COUNCIL ASSESSMENT REPORT – MODIFICATION APPLICATION NORTHERN REGIONAL PLANNING PANEL

PANEL REFERENCE & DA NUMBER	PPSNTH-432 – DA22/0408.02
PROPOSAL	Section 4.55(2) modification to residential flat building (78 units) in 3 x 4 storey blocks and 1 x 2 storey block with a common basement (NRPP)
ADDRESS	Lot 46 DP 1264557; No. 6 Grand Parade CASUARINA
APPLICANT	Town Planning Alliance (NSW) Pty Ltd
OWNER	Azure Project 35 Pty Ltd
MOD LODGEMENT DATE	9 July 2025
ORIGINAL DA DETERMINATION DATE	19 March 2024
APPLICATION TYPE	Section 4.22(2) Modification Application
REGIONALLY SIGNIFICANT CRITERIA	The original application was determined pursuant to Section 2.19, Schedule 6 of State Environmental Planning Policy (Planning Systems) 2021: development that has a capital investment value of more than \$30 million. Given Council recommended refusal of the original application, the modification application is to be determined by the panel.
ESTIMATED DEVELOPMENT COST	\$64,454,864.00 (excluding GST)
CLAUSE 4.6 REQUESTS	N/A

PREVIOUS BRIEFINGS	NIL
RECOMMENDATION	Approval
SCHEDULED MEETING DATE	9 December 2025
PREPARED BY	Hayley Nilon – Development Assessment Planner
DATE OF REPORT	28 November 2025

Figure 1 Extract from Existing Site Survey Plan indicating existing location of Electrical substation easement and proposed location outlined in red.

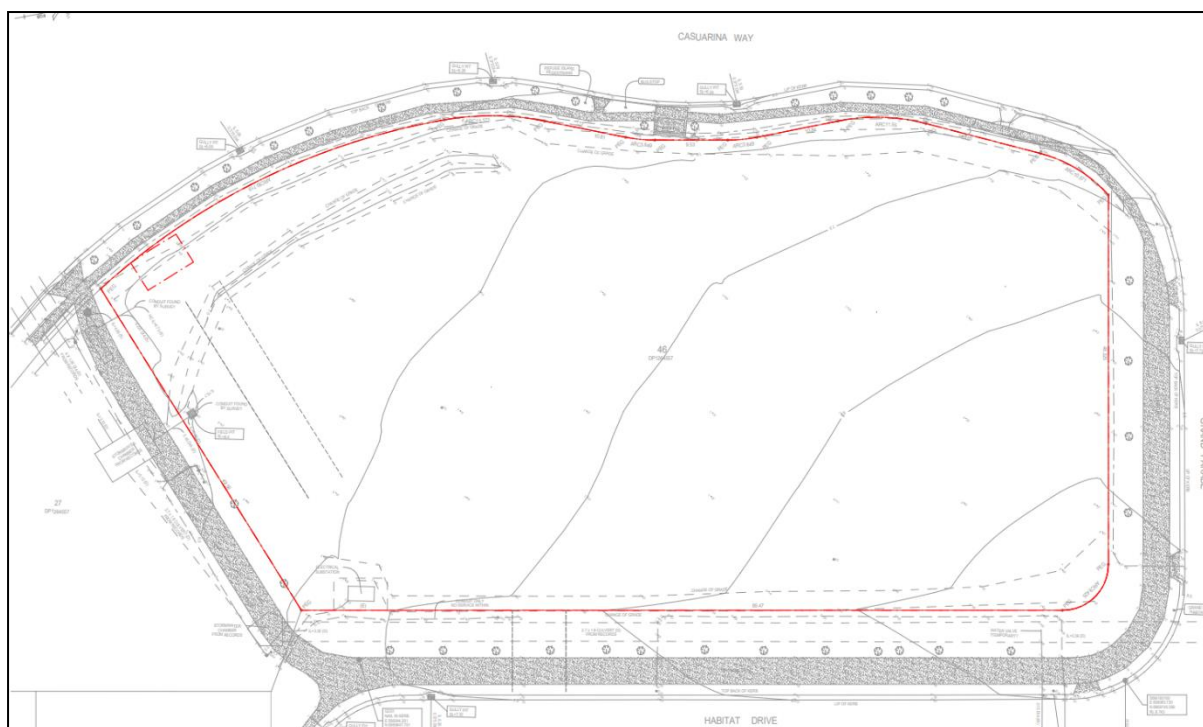
The proposed modification maintains the originally approved relocation of the pad mounted substation from the south-eastern corner to the south-western corner of the site. Given the changes proposed to the building footprints and facades, the proposed modification was referred to Essential Energy pursuant to Clause 2.48 of SEPP (Transport and Infrastructure) 2021. It is considered that safety concerns raised can be managed through imposition of additional conditions. Refer to Section 3 of this Report for more details.

Figure 21 Proposed Basement floor plan

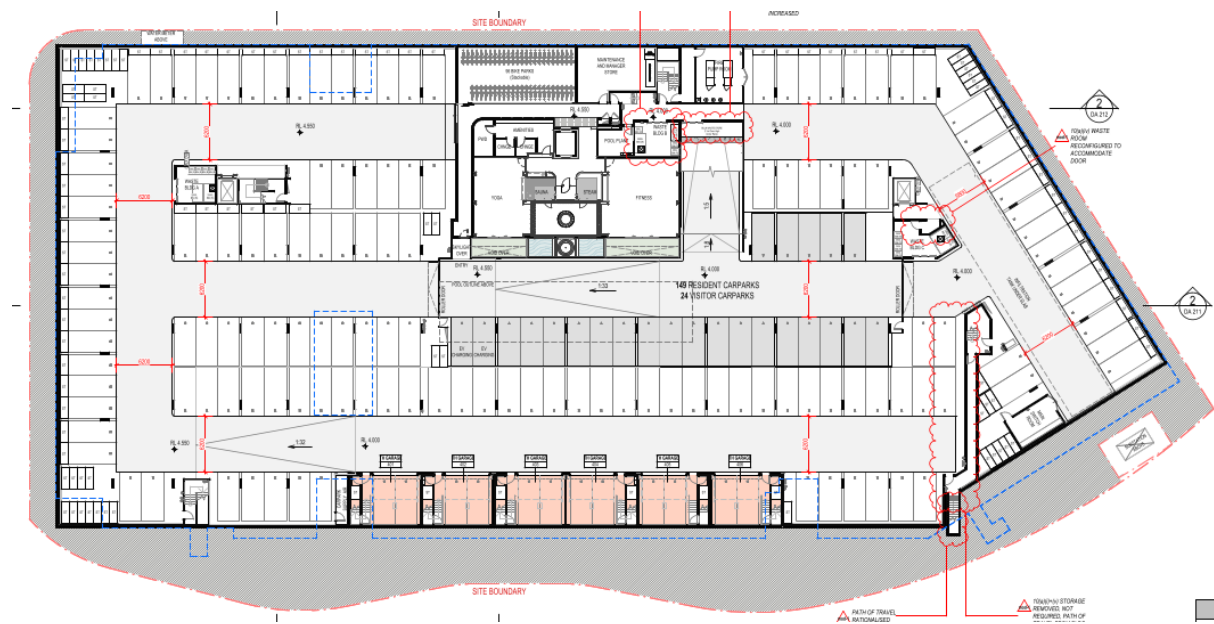
<i>certificate for buildings'</i>		
Basement layout	A revised basement layout addressing the following: • Unit storage areas located below Building C are inaccessible when vehicles are in the carpark. • The basement plan indicates an excessive amount of storage areas which does not accord to the number of units, nor with the number of units which are providing basement storage. • A separate basement storage and parking allocation plan should be provided to ensure sufficient storage is provided and is accessible to the relevant unit. • No pedestrian access between Building B lift and Building B Waste Storage area. • There is no clear pedestrian access between Building D and Building C waste room without crossing through carparking spaces. • Building B waste room is not of a sufficient size to accommodate the additional bins required whilst allowing for easy	The basement layout has been revised to address Council's comments, specifically: • All of the storage areas provided are appropriately accessible. • The storage areas in the basement have been reviewed and rationalised in response to Council's comments and complies with the ADG. • The provision of storage in the basement will ensure all apartments meet or exceed the minimum requirements of the ADG. The allocation of storage in the basement will occur as part of future strata subdivision. • The basement floor plan has been amended to provide pedestrian access between the Building B lift and waste storage area. The Operational Waste Management Plan has also been updated to include e-diverter chute hoppers for Building A, B and C that will enable residents to dispose of waste and recycling directly through the	Yes

access and manoeuvrability. • The deletion of the bulk waste room in the basement is not supported. • The revised Waste Management Plan is not consistent with the application plans in respect of bin numbers and requires updating.	e-diverter chute hoppers on each level without the need to access the waste rooms in the basement. Residents of Building D (townhouses) will continue to dispose of their general and recycle refuse directly into the bins in the waste room located on the basement under Building C. • Clear pedestrian access is now provided between Building D and Building C waste room. • Building B waste room has been increased in size and is sufficiently sized to accommodate the required bins and bin tug. • The basement floor plan has been updated to accommodate a bulk waste room adjoining the Building B waste room. • The architectural plans have been updated to ensure bin numbers within the respective waste rooms are consistent with the Operational Waste Management Plan by Colliers.

Figure 25: Proposed modification and building elements which exceed the 13.6m Tweed LEP 2014 height plane.

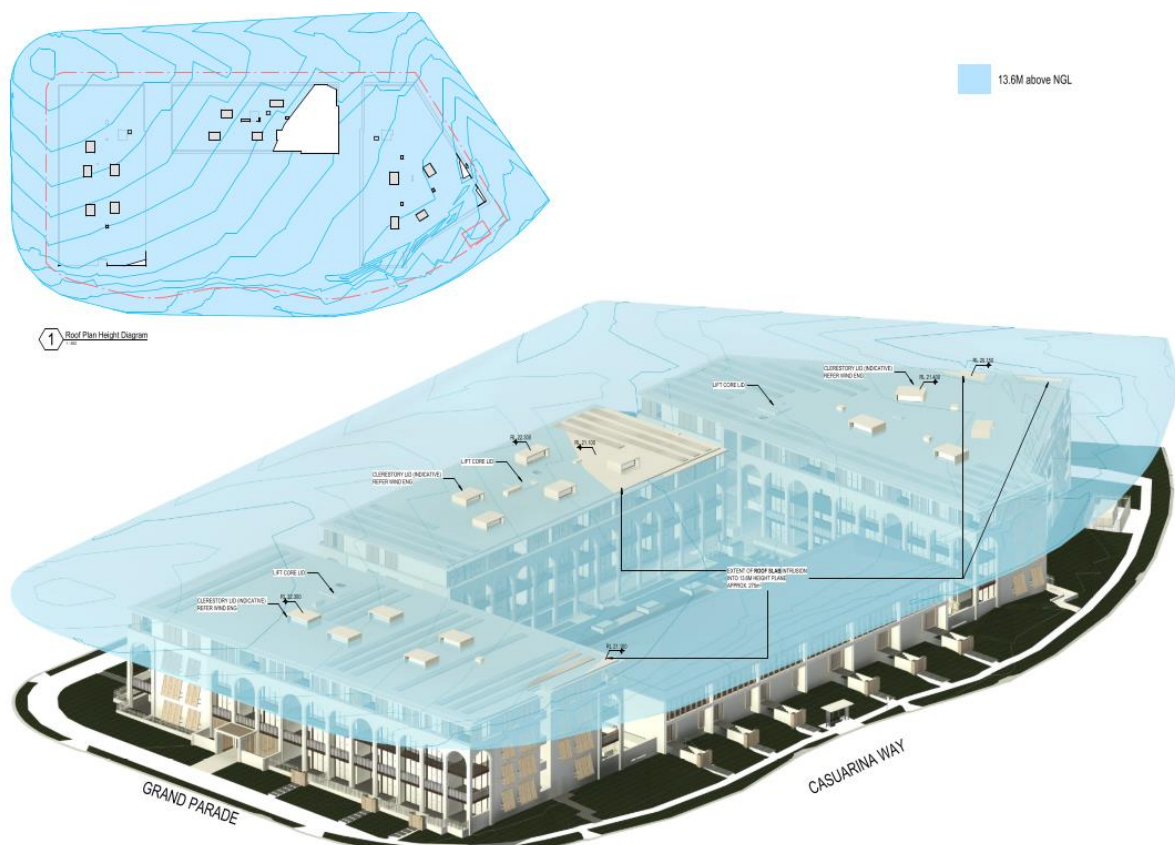
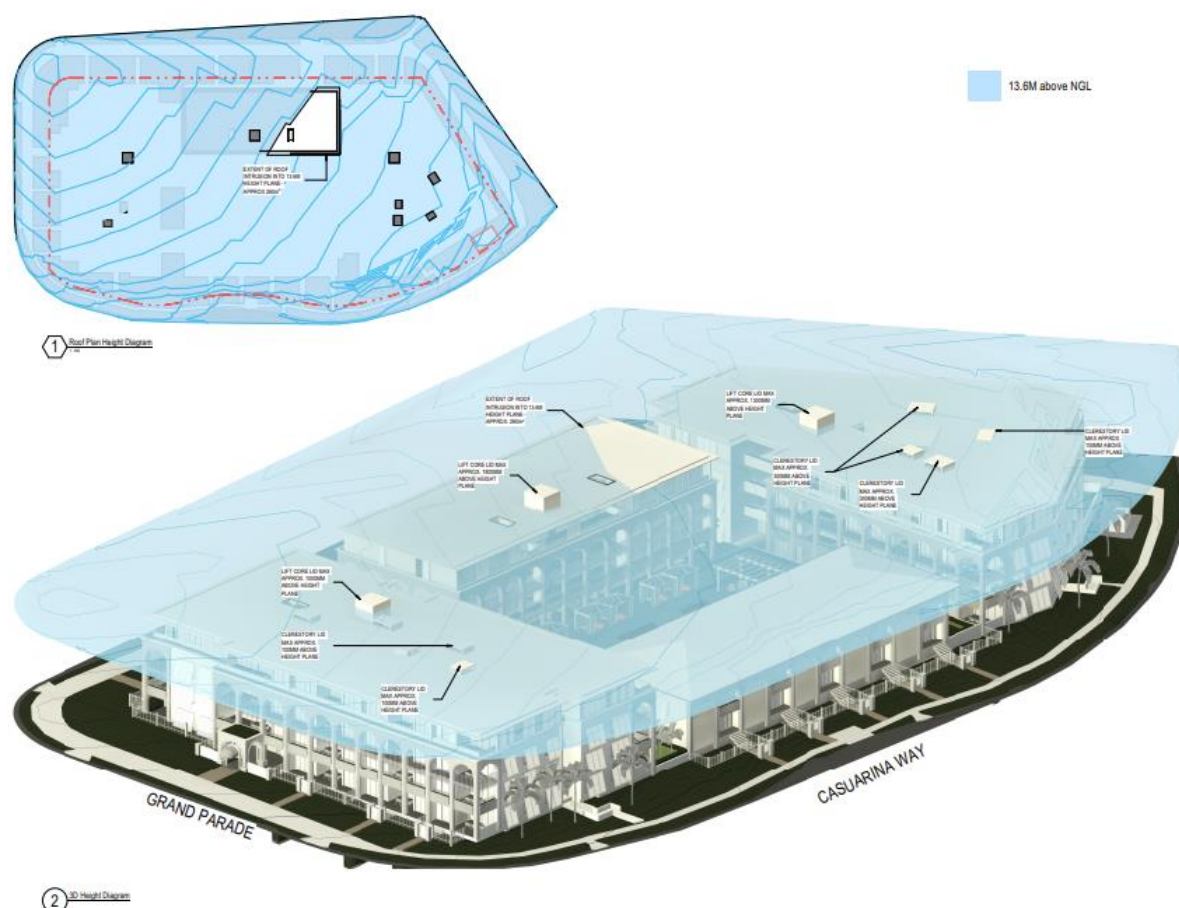
In relation to the 13.6 metre height limit under the TLEP 2014, for comparison purposes, a portion of each of the roofs, clerestory lids and lift core for modified Buildings A, B and C exceed the 13.6m building height limit as shown in Figures 25 and 26, which equates to 275m². This is a 15m² increase from originally approved where only the roof for Building B, clerestory lids and lift core exceeded the 13.6m building height limit. This is considered to be similar to originally approved.

Figure 30 Proposed Landscape Concept Plan – Deep Soil Zones Structure Diagrams

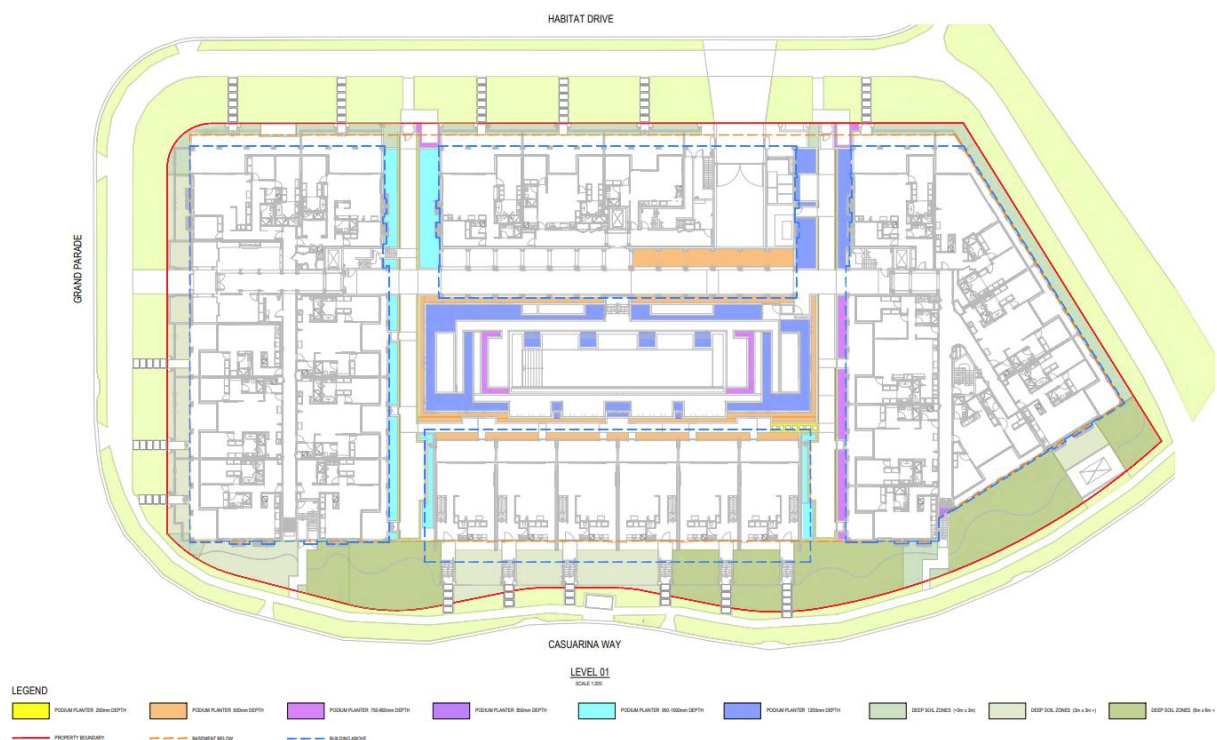
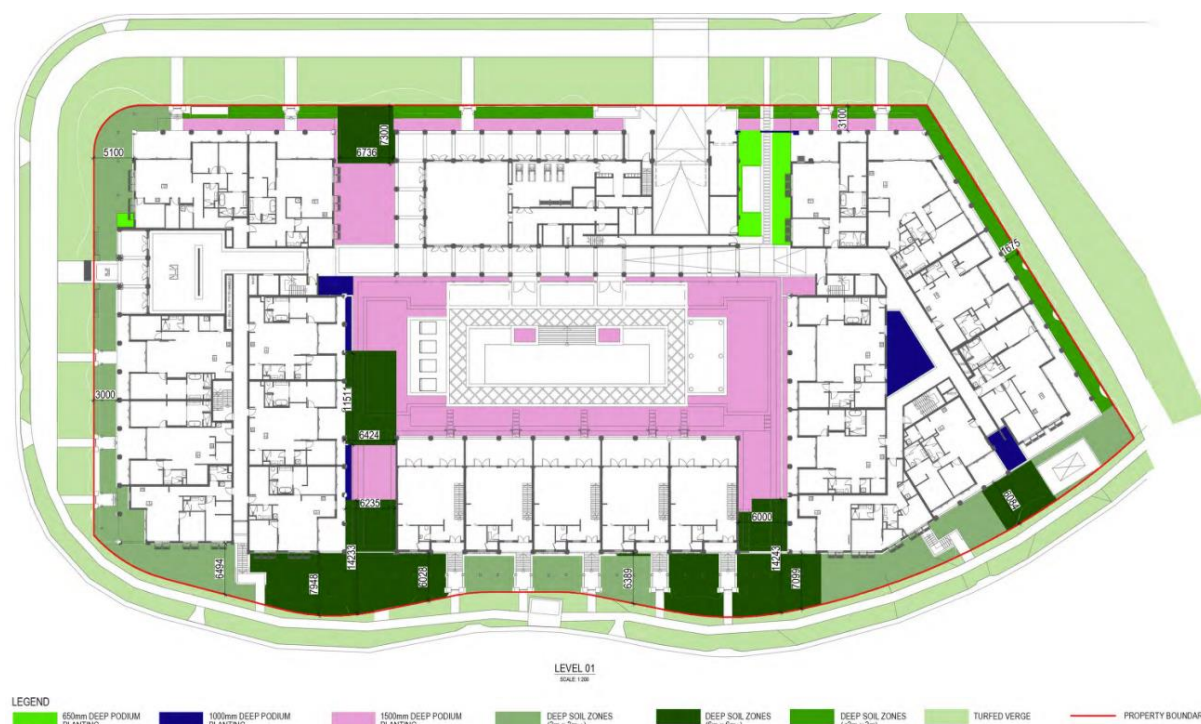
below in figures 30 and 31. The revised Landscape Concept Plan indicates that this area will contain the following tall palms which are underplanted with shrubs and groundcovers:

- *Howea forsteriana* (Kentia Palm) – 10-15m mature height; 5-6m mature width
- *Phoenix roebelenii* (Dwarf Date Palm) – 2-4m mature height; 2-4m mature width
- *Plumeria obtuse* (Evergreen Frangipani) – 8m mature height; 5m mature width

The planters proposed between Buildings C-D are of similar dimensions as originally approved, with narrow planters surrounded a lawn area. The planters proposed between Buildings A-D have been significantly reduced from the originally approved width of 5.3m to 0.7-1.1m. Whilst this is a significant reduction, they are similar to those between Buildings C-D and are therefore considered acceptable. In respect of the planters within the swimming pool area, these are considered to be generally similar to those originally approved.

It is noted that Condition 17 which requires submission of a detailed landscaping plan prior to issue of a Construction Certificate is being maintained, albeit with a revision to the reference to the Landscape Concept Plan. This detailed landscaping plan will clearly identify species and planting locations.
